UNITED STATES  
DEPARTMENT OF THE INTERIOR  
BUREAU OF LAND MANAGEMENTFORM APPROVED  
OMB NO. 1004-0137  
Expires: January 31, 2018**SUNDRY NOTICES AND REPORTS ON WELLS**  
*Do not use this form for proposals to drill or to re-enter an abandoned well. Use form 3160-3 (APD) for such proposals.***SUBMIT IN TRIPLICATE - Other instructions on page 2**

| 3b. Phone No. (include area code)<br>Ph: 817.334.8302  | 8. Well Name and No.<br>LINDRITH NP 114                   |

SRC requests approval to plug and abandon the Lindrith Unit NP #114.  
Attached are the Proposed Procedure, WBDs, and Reclamation Plan and Owner Letter.

**CONDITIONS OF APPROVAL**

## PROPOSED P&A

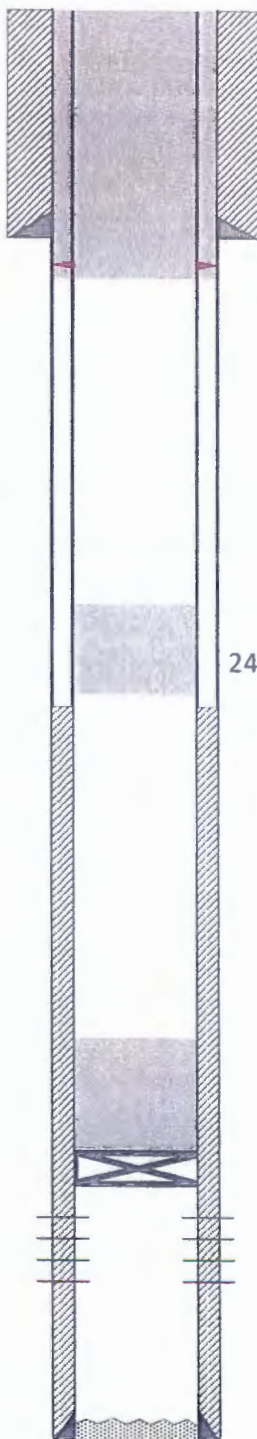
1. Plugging operations authorized are subject to the attached "General Requirements for Permanent Abandonment of Wells on Federal and Indian Lease."
2. Farmington Office is to be notified at least 24 hours before the plugging operations commence (505) 564-7750.
3. **Plug number 1:** Operator must run a CBL (3270' – surface). Submit electronic copy of the log for verification to the following addresses: [jkillina@blm.gov](mailto:jkillina@blm.gov) and [Brandon.Powell@state.nm.us](mailto:Brandon.Powell@state.nm.us) . Based on CBL results inside/outside plug may be required. Cement volumes may be adjusted accordingly.
4. **Plug number 2:** Inside and Outside plugs will be required based on CBL and historical Temperature Survey results. Adjust proposed inside/outside cement interval (1500-1200) volumes accordingly.
5. **Plug number 3:** as proposed
